801

2115 / 2121 WESTLAKE AVE
SEATTLE, WA 98121
PROJECT # 3037037 - EG

EARLY DESIGN GUIDANCE 2
DATE: 7/6/2021

ITEMIZED RESPONSE TO EDG #1 - BOARD RECOMMENDATIONS

CONCEPT 4_Ground Floor Landscape Concept

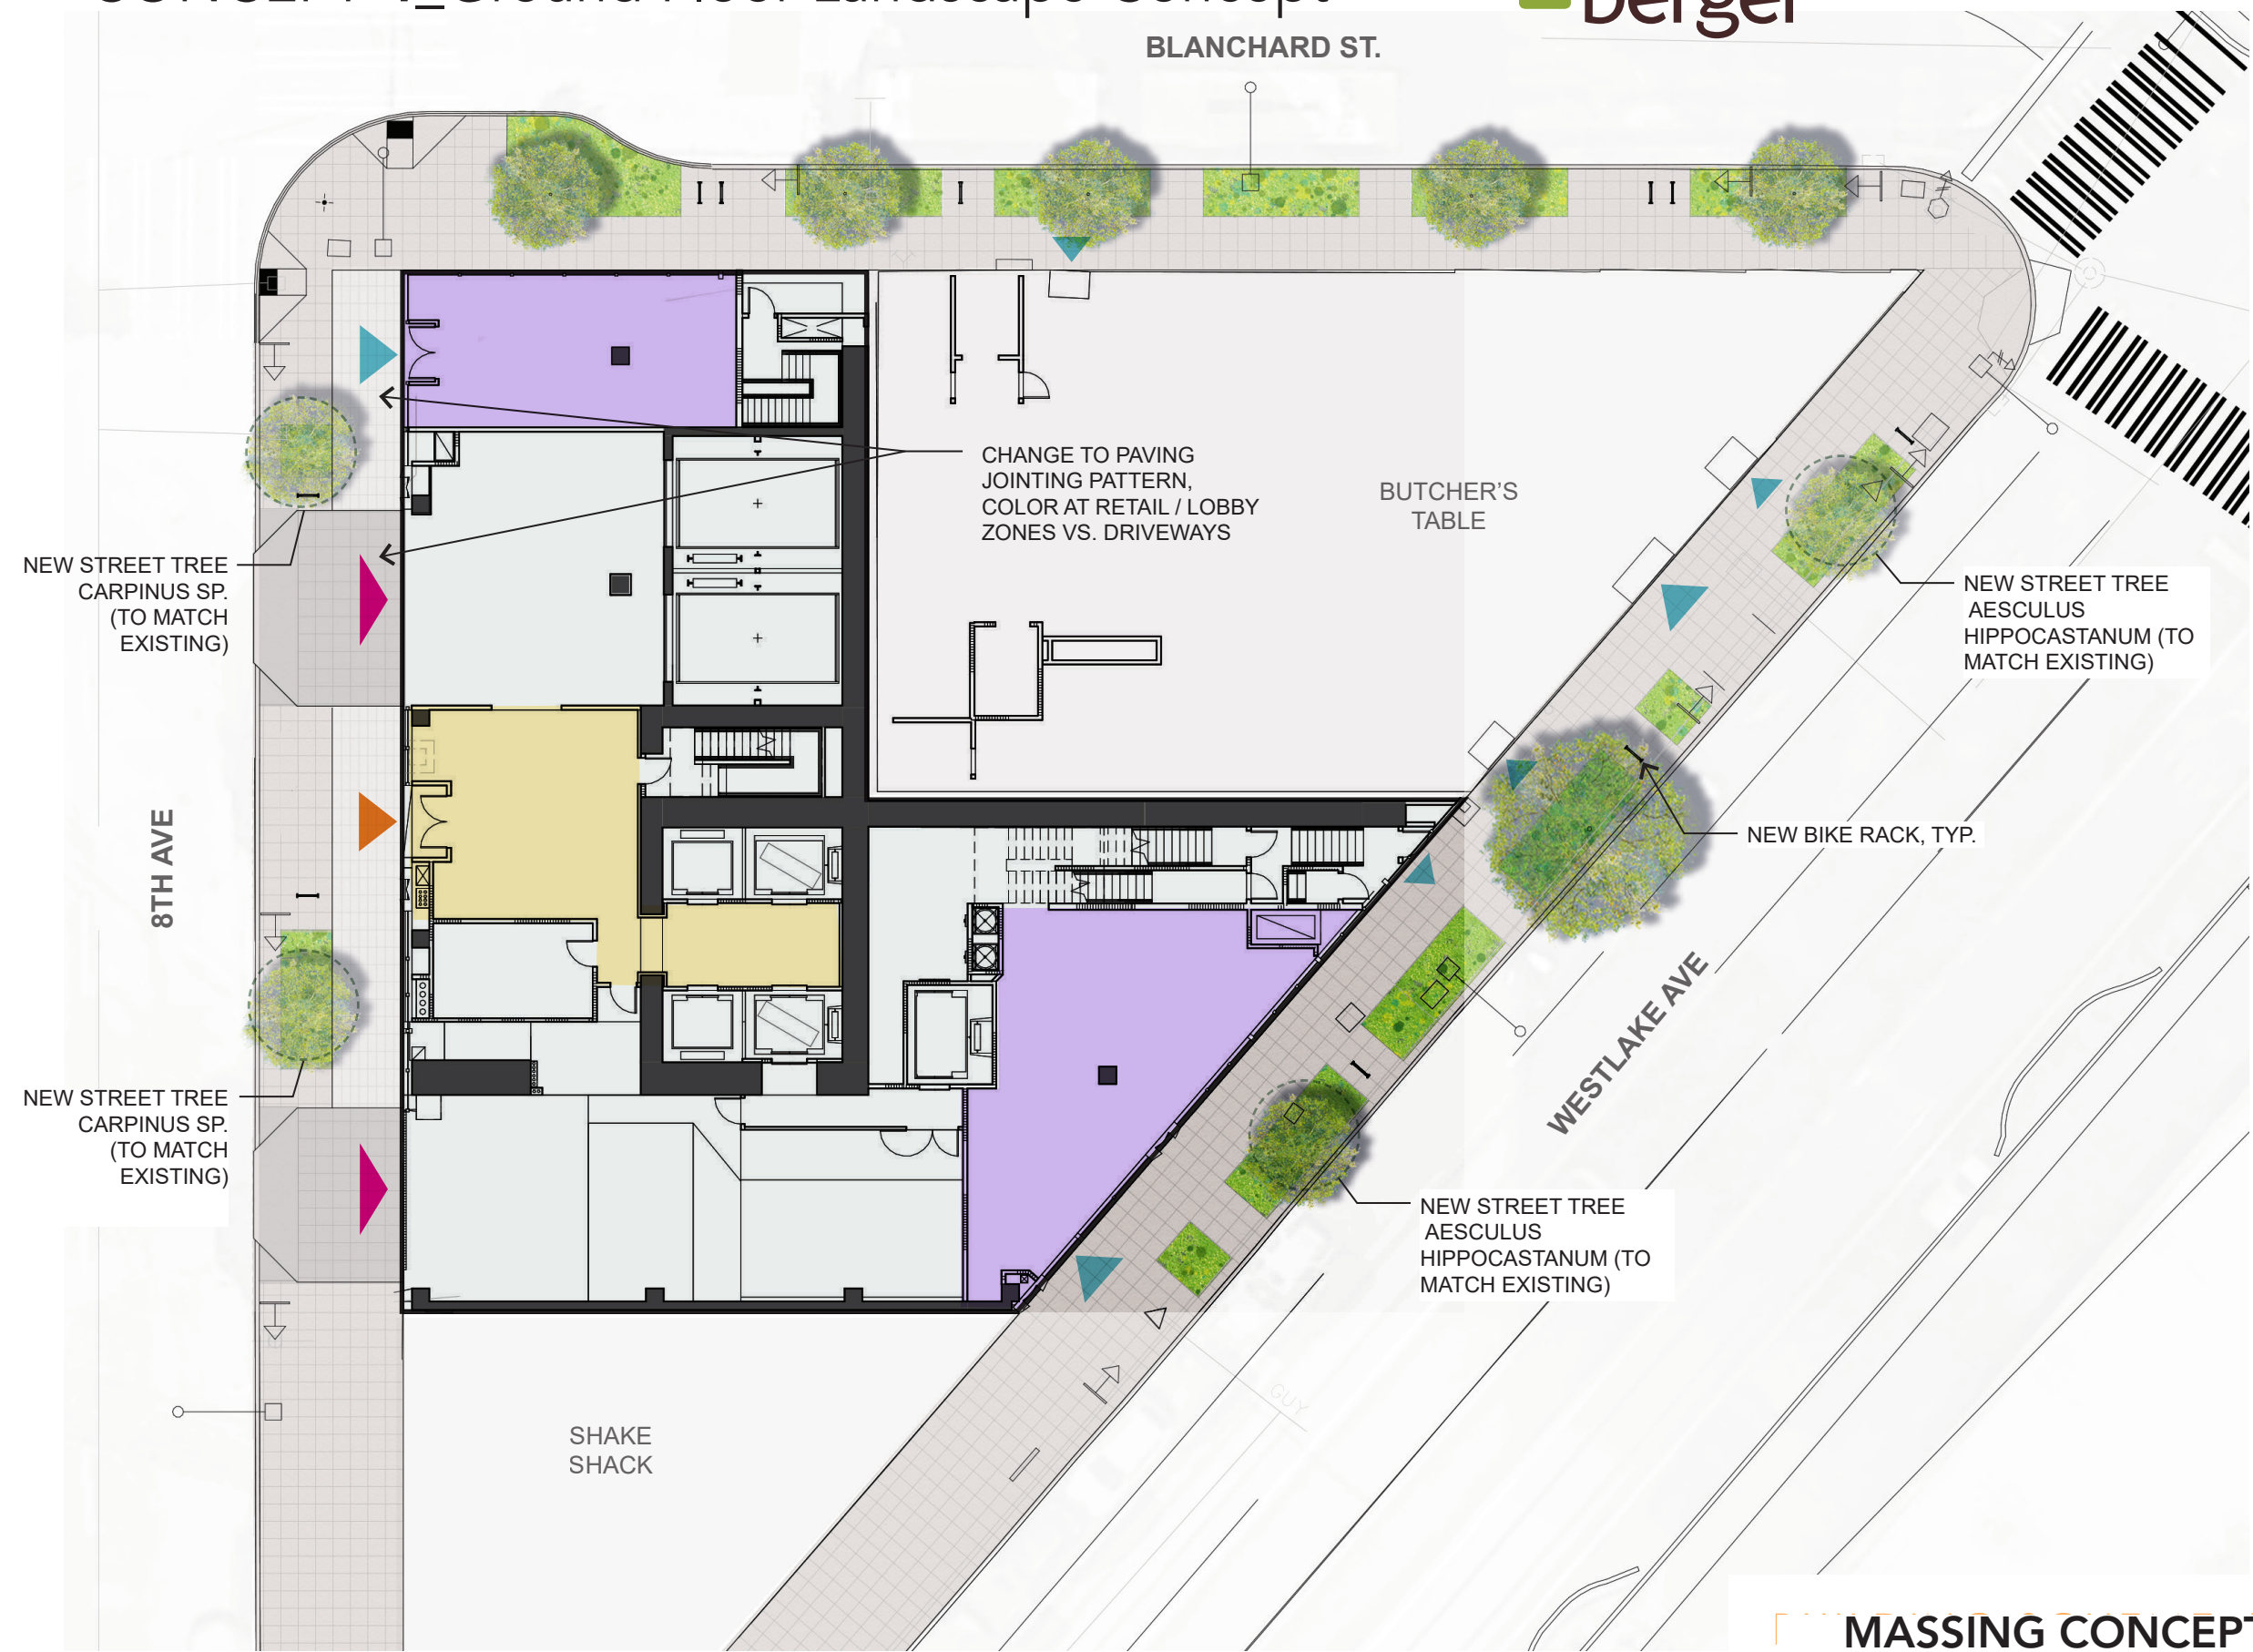
d.	<p>d. The Board considered the preliminary ground level landscape concept plan and supported the fact that it is generally consistent with the existing urban design language along each frontage. The Board encouraged further consideration of how the landscape plan can be designed to embrace entries and the residential lobby. (D-2)</p>	<p>Landscape plans have been revised and made unique for each ground floor option. As previously appreciated by the board, the plans aim to continue and complete the existing urban design language along each frontage. As a response to comments, paving pattern and color has been utilized to distinguish and emphasize building entrances. (D-2, C-1, C-4)</p>

- engage 8th and Blanchard corner with potential bulb-out
- add planting strip with paved openings for drop-off & bike racks
- keep existing street trees and enhance with bigger planters

- add new street planters
- remove existing street trees to open views of lobby entrance, add two new street trees
- create smaller paving pattern through unique scoring at retail and residential frontages
- distinguish building entries from driveway zones with change to paving jointing pattern, color, finish

- expand and enhance planters to create strong green edge
- add bike racks
- add street trees where possible

CONCEPT 5_

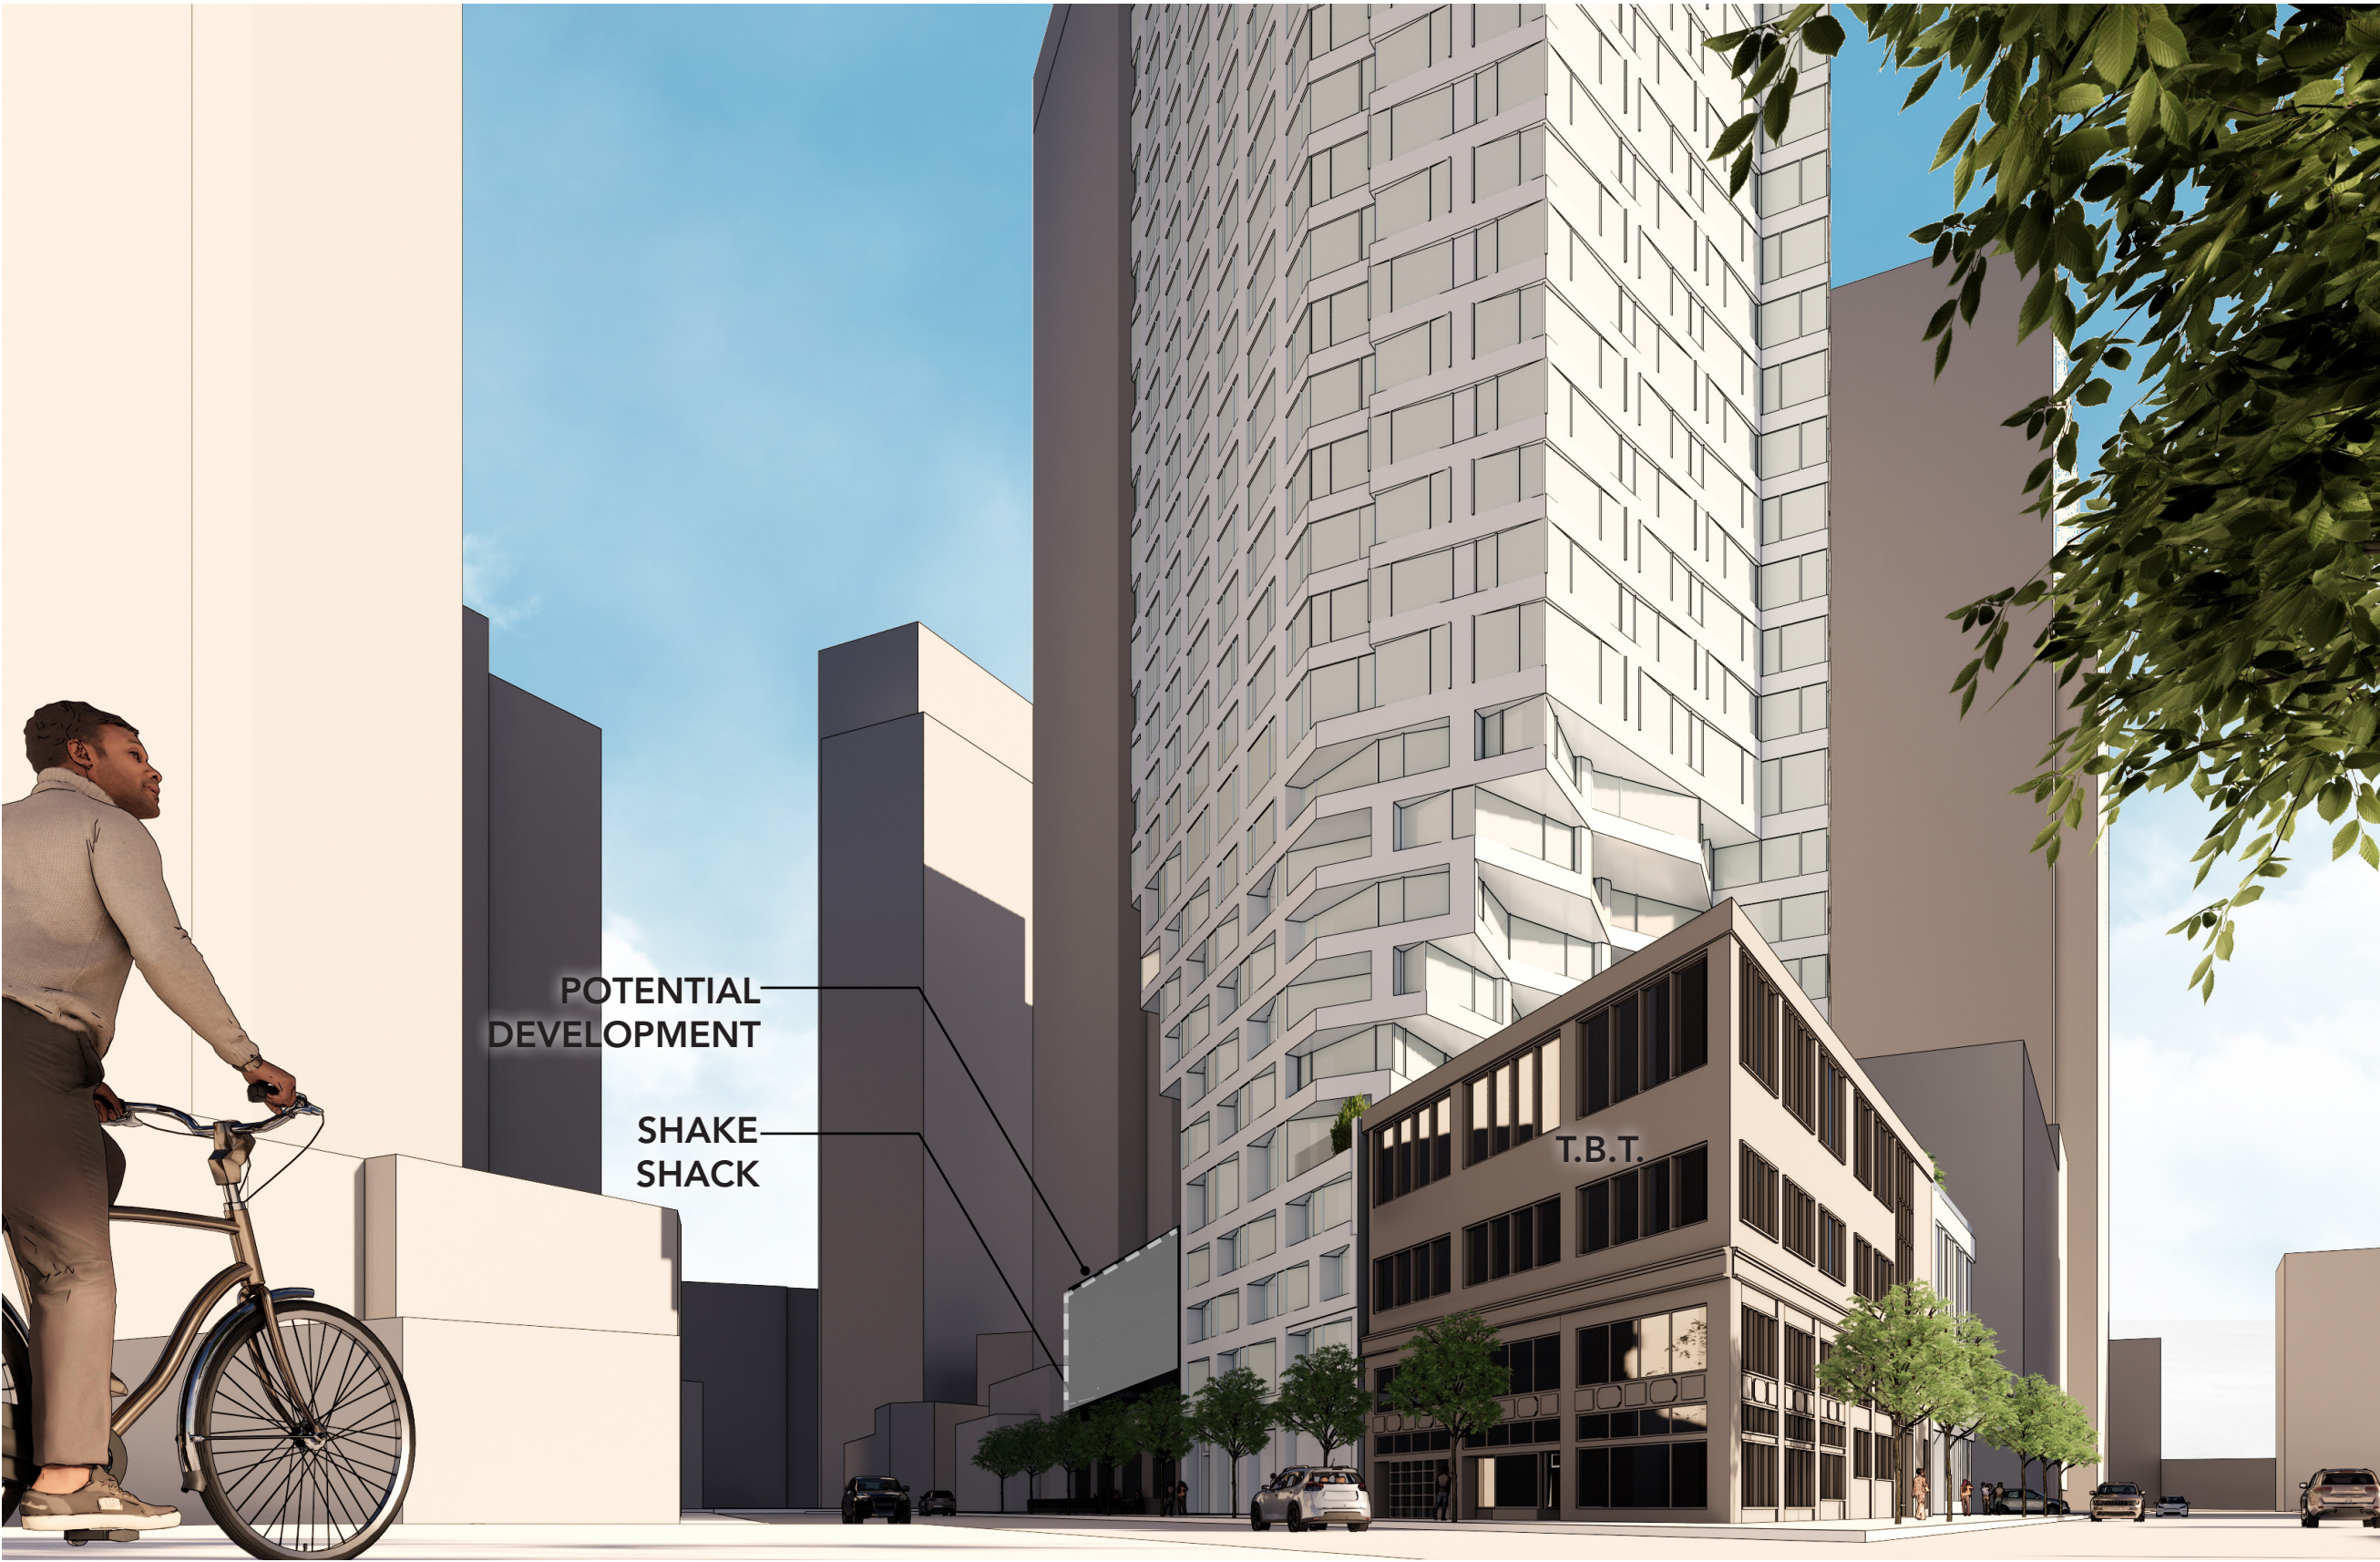
c.	<p>The Board directed further study of the scale of the overhang above the existing 4-story building (Butcher's Table) and the negative space between the two structures. The Board stated that the resolution of the architecture of the overhang should inform the development of a well-proportioned building and consistent overall architectural expression, and specifically prioritized Downtown Design Guideline B-4, Design a Well-Proportioned & Unified Building.</p> <p>i. The Board admired the simplicity of the overhang of Option 1; however, they would like to see more relief granted to the existing building, but not necessarily to the extent of the angled overhang of Option 2 or the faceted overhang of Option 3.</p> <p>ii. The Board appreciated that the overhang of Option 2 contributed to a more slender form.</p> <p>iii. The Board generally supported the unique expression of the faceted overhang of Option 3, but was concerned that the language of the facet was not repeated elsewhere. The Board recommended further study of reducing the scale of the facets by half – so as to not detract from the adjacent buildings – and incorporating the language of the facet into other aspects of the design for a uniform architectural expression. (B-1, B-4, B-4.1)</p>	<p>In Concept 4, The architectural language of the overhangs has been unified to a simple vertical fabric, which is integral to the whole of the building – base, middle, and top. (B-4.b) for a more unified building.</p> <p>This approach is intended to be an elegant transition that does not compete with the existing buildings on the block (B-1.b).</p> <p>In Concept 5 the scale of the overhang has been reduced using a concept of terraced setbacks. The terrace setbacks are articulated in an 'interlocking' pattern to be unified with the larger massing concept. (B-4) For coherence with the adjacent buildings, the size of the individual setback facets reflects the window bay size of the existing buildings on the block. (B-4.1.b.)</p> <p>The approach provides a scale modulation that is compatible with the existing buildings and also provides adequate relief. (B-1.b)</p>

-Directed further study of the scale of the overhang above the existing 4-story building (Butcher’s Table) and space between the two structures.

-Resolution of the architecture of the overhang should inform the development of a well-proportioned building and consistent overall architectural expression

In Concept 5 the scale of the overhang is reduced through a concept of terraced setbacks which are articulated in an 'interlocking' pattern to be unified with the larger massing concept. **(B-4)** For coherence with the adjacent buildings, the size of the individual setback facets reflects the window bay size of the existing buildings on the block. **(B-4.1.b.)**

-The approach provides a scale modulation that is compatible with the existing buildings and also provides adequate relief. **(B-1.b)**
